ADDENDUM NO. 03

DATE: May 5, 2020

PROJECT: Inglemoor High School Concert Hall + Music Building Project

7 STAIR B 103 - BENCH PLAN
SCALE: 1/4" = 1'-0"

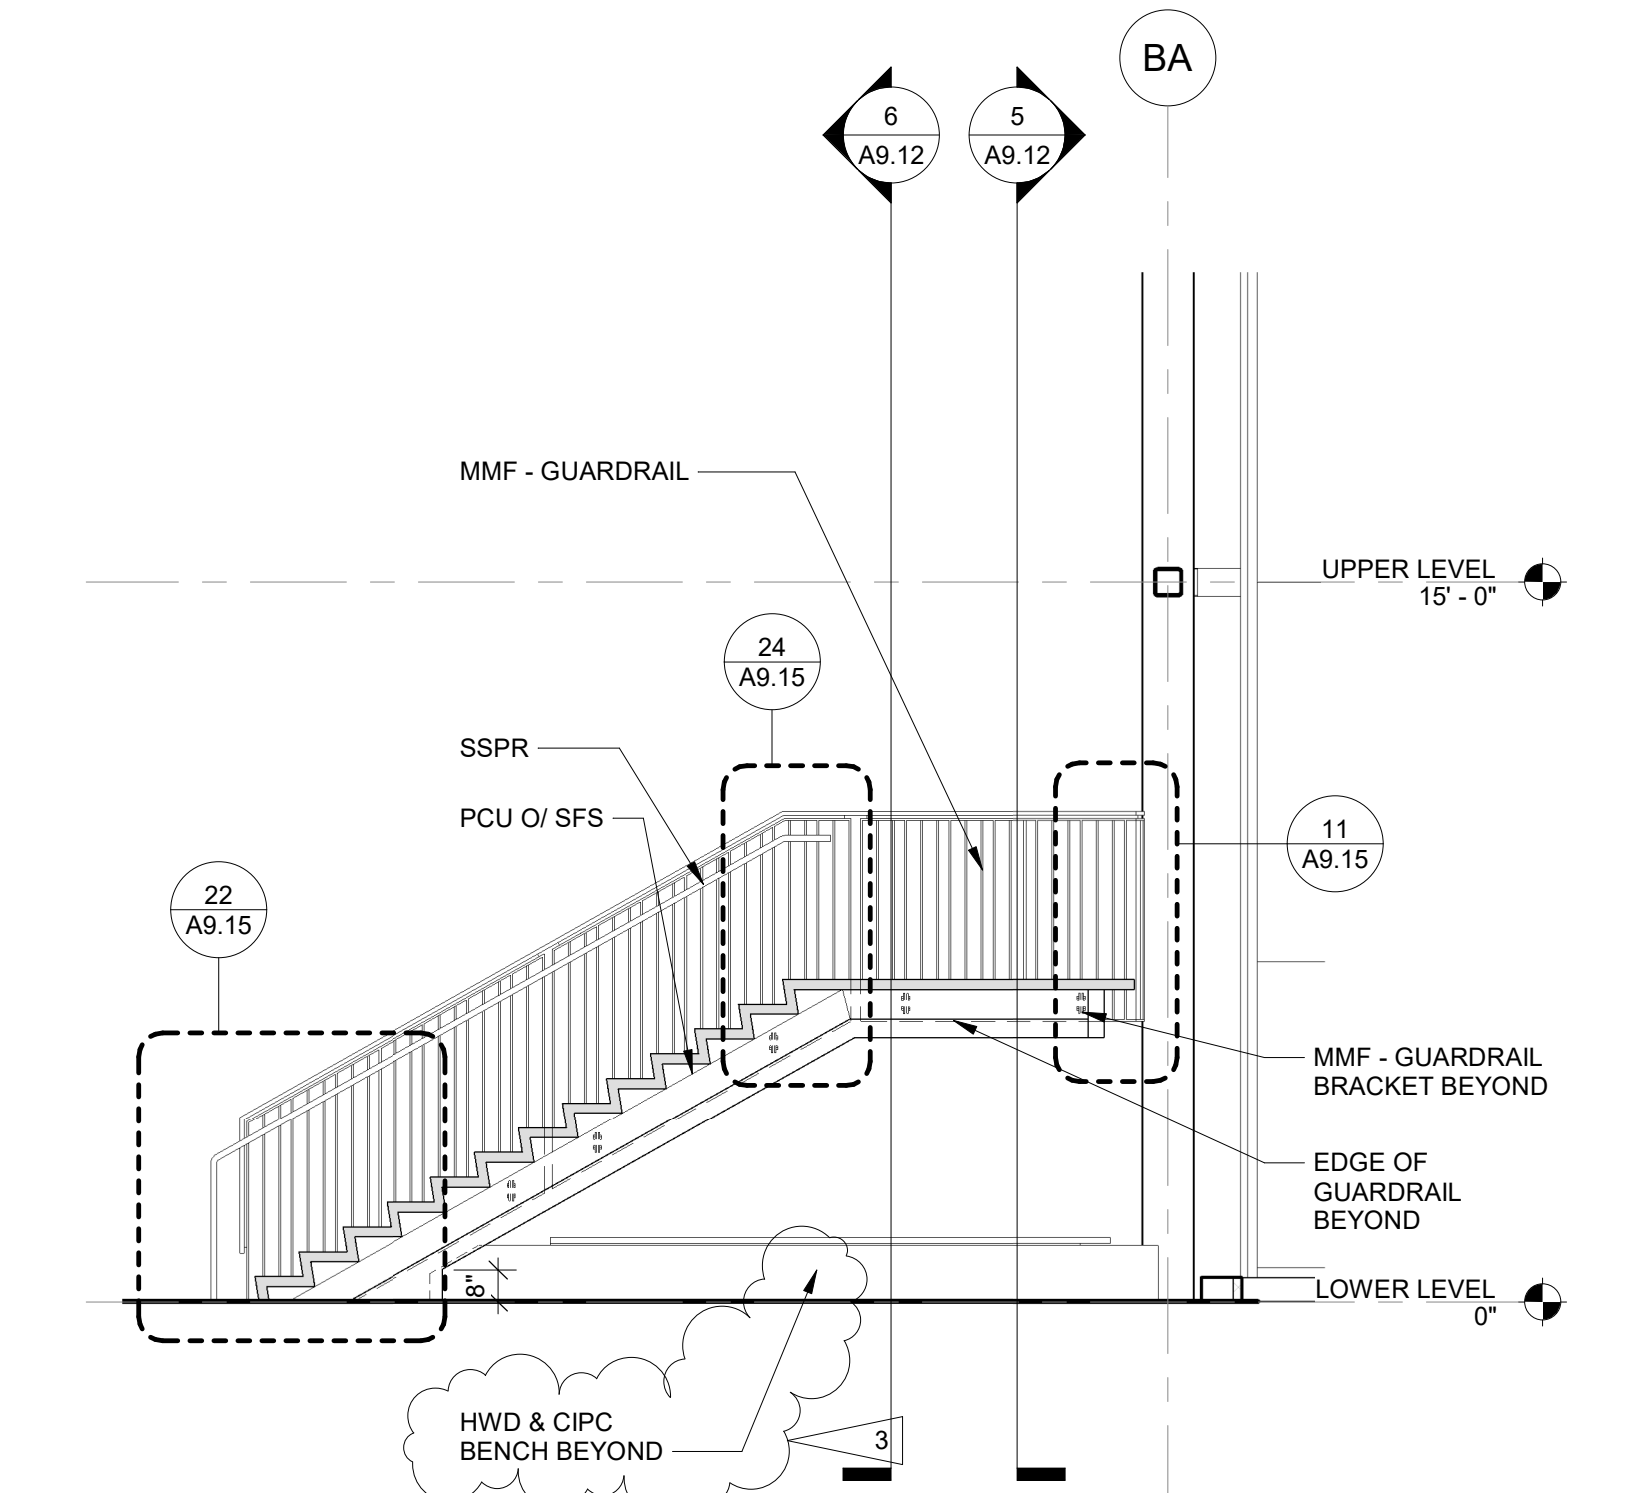
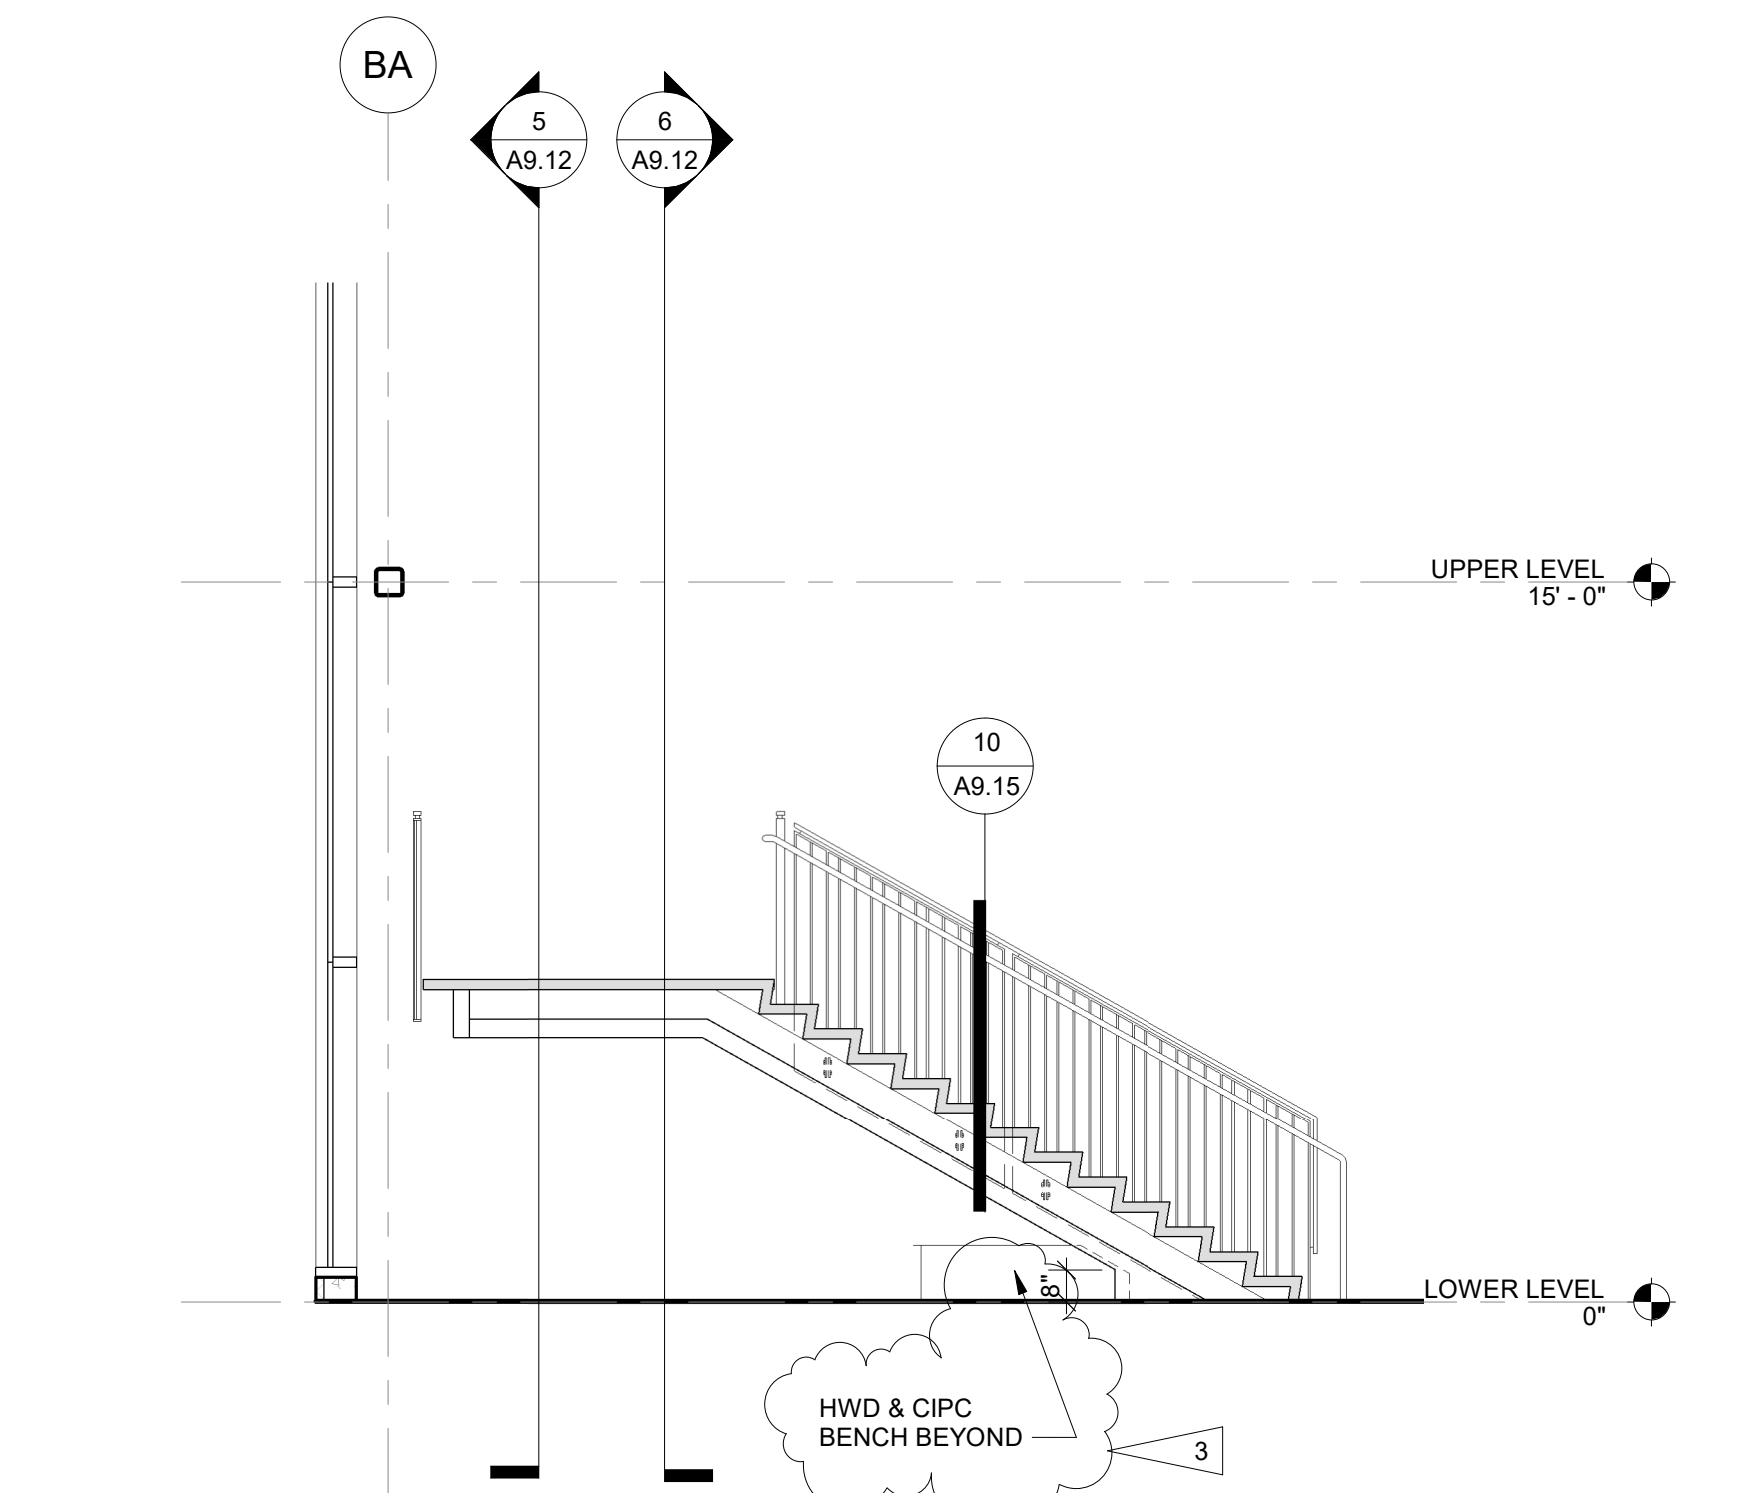
1. On Detail 2, 3, 5, 6, 7, 8, and 9, REVISE per attachment A4.46

3 RELITE TYPES (HMF) - STC50

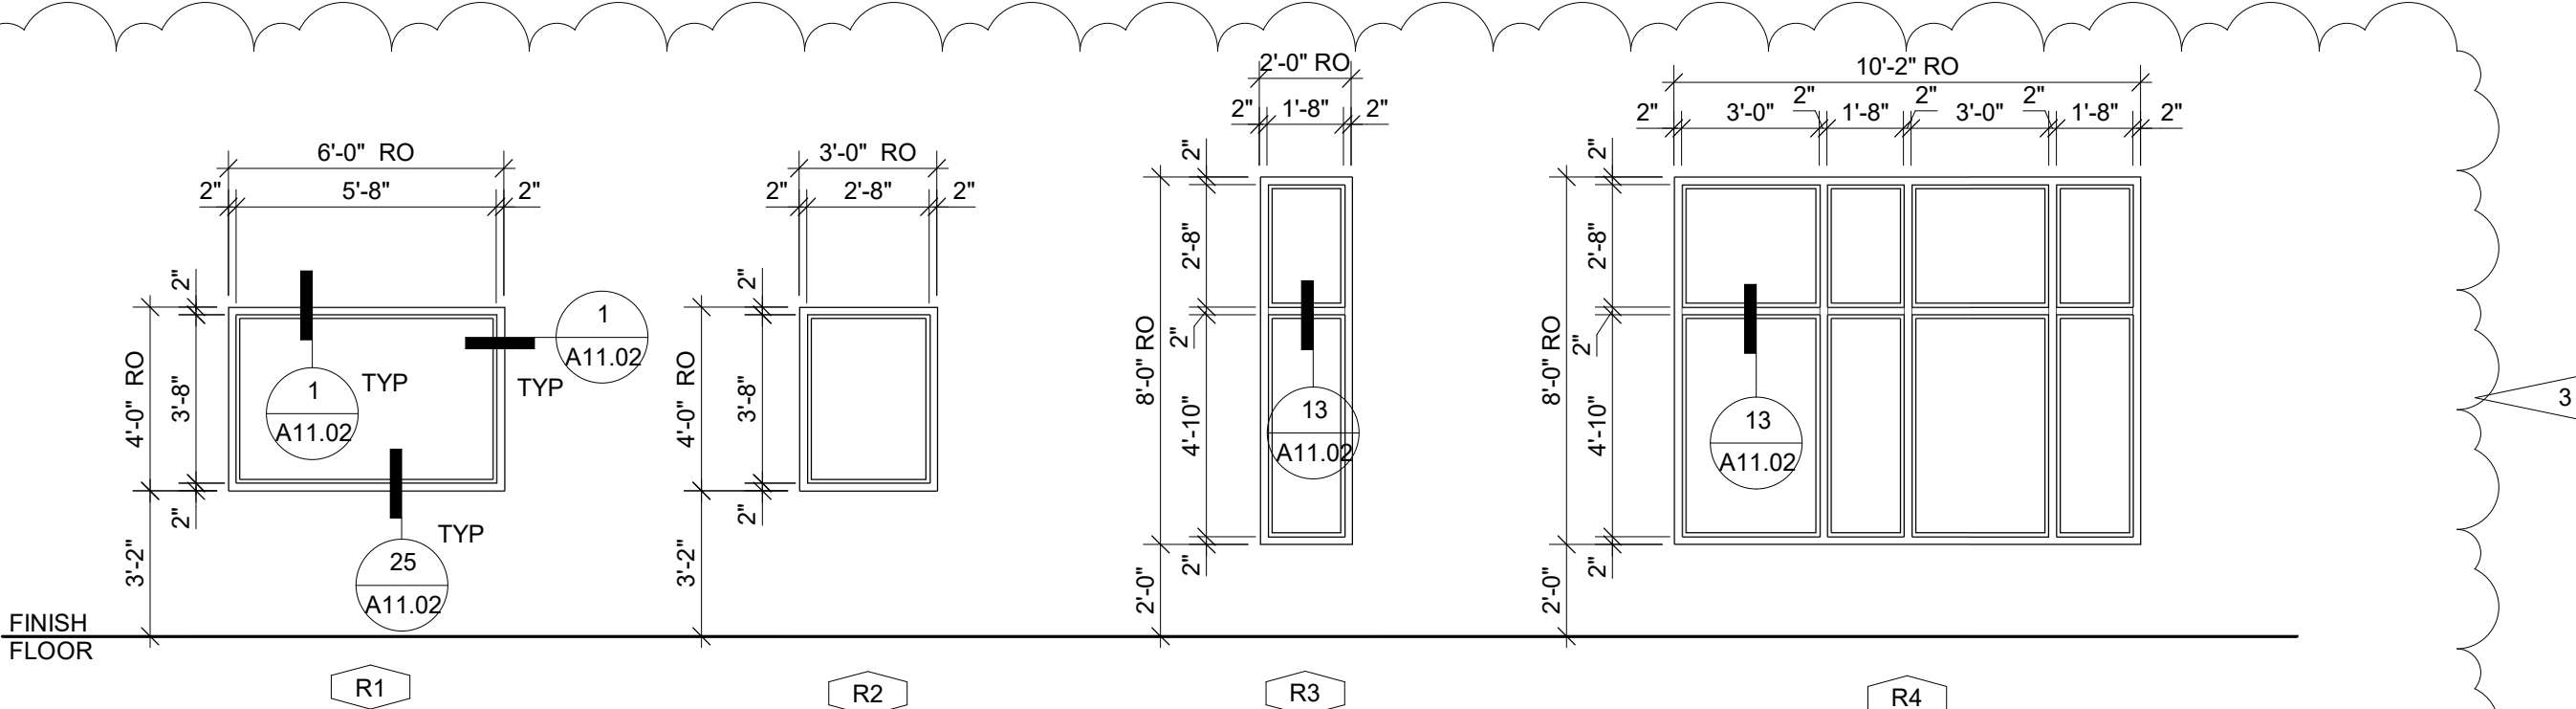
2. *QUESTION: Relites R1 thru R4 drawn on Sheet A11.01 are constructed of Hollow Metal and the Details which are shown on Sheet A11.02 do not indicate any Sound Transmission Coefficients. The frame construction is drawn as single glazed with standard HM removable stops.*
- A. Relite R1 is located in Office 139. The Door In the same wall is noted to have an STC45 rating. Will Relite R1 also be required to be STC45?*
- B. (2) Relites R2 are located in the Choir Staff Office 220. The Doors in the same wall are noted to have an STC50 rating. Are Relites R2 also to be STC50?*
- C. Relites R3 and R4 are in the Music Tech Room 221. Will these Relites also be rated at STC50?*

1. On Detail 3, ADD STC50 rating per attachment A11.01

ANSWER: For Hollow Metal Frame Relites R1 – R4, provide glazing assembly that meets an STC50 rating.

4 ALUMINUM WINDOW - DUAL SLIDING

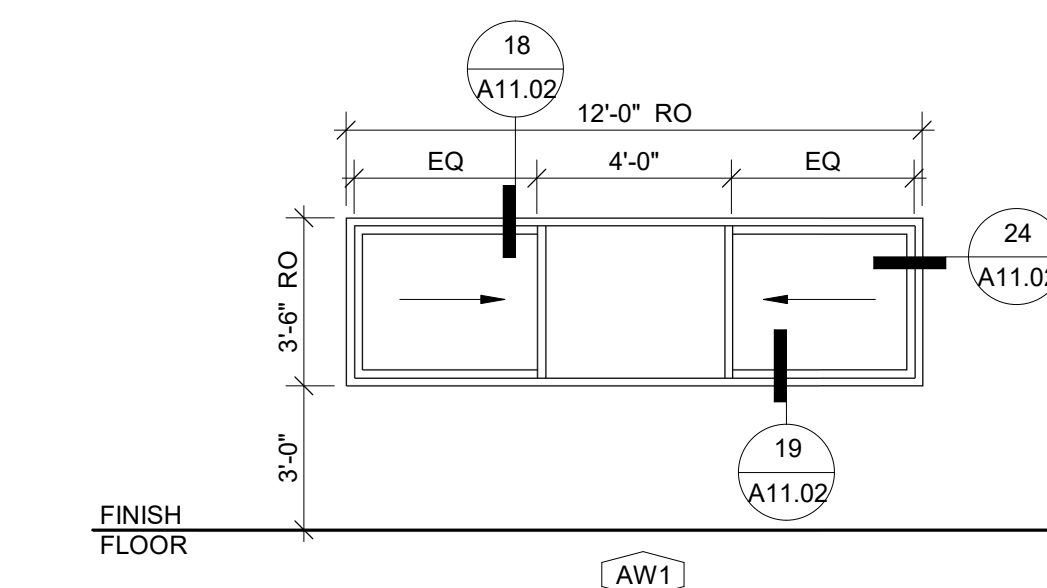
3. *QUESTION: Relite AW1 is noted to be a Sliding “Aluminum” Window. There is no STC Rating noted. Will this window be furnished by the Aluminum Storefront contractor?*

ANSWER: Aluminum Sliding window at Control Booth is not STC Rated and should be furnished by BP-08.1 Trade Contractor.
